CITY OF ALBUQUERQUE

Re: **Murphy (Oil) Express**
10601 Unser Blvd NW
Traffic Circulation Layout
Engineer's Stamp 06-15-2022 (A11-D017A)

The TCL submittal received **06-15-2022** is approved for Building Permit with. A copy of the stamped and signed plan will be needed for each of the building permit plans. Please keep the original to be used for certification of the site for final C.O. for Transportation.

SHEET NO. TCL-1

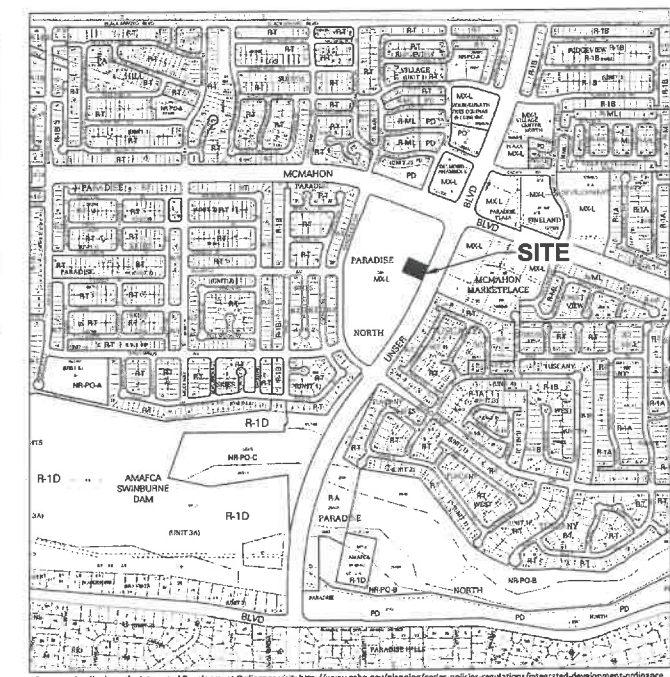
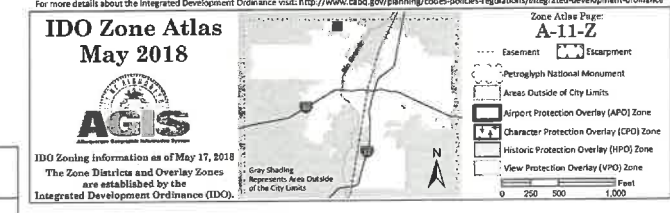
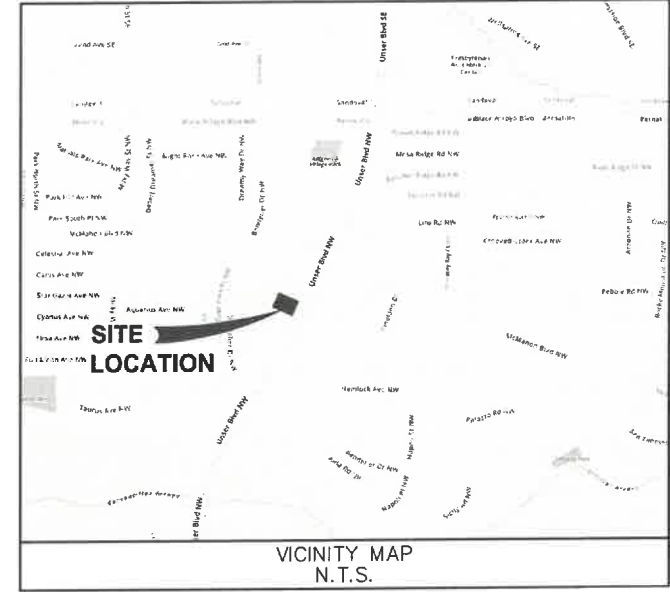
A Condition of Final C.O. Approval :

- Easement for Public Access be completed and approved.
 1. Bandelier - Lot 5/6.
 2. 30 ft: Unser Entrance-West(26 ft Access Easement).
- Work Orders be completed/approved:
 1. CPN 683083: 30 ft wide Access drive aisle.
 2. CPN 683084: Right turn lane.

1. **ESSENTIAL FOR PUBLIC ACCESS TO BE COMPLETED/APPROVED:**
 - BANDELIER TO LOT 5/6.
 - 30FT. UNSER ENTRANCE.
2. **WORK ORDERS BE COMPLETED/APPROVED:**
 - CPN 683083.
 - CPN 683084.
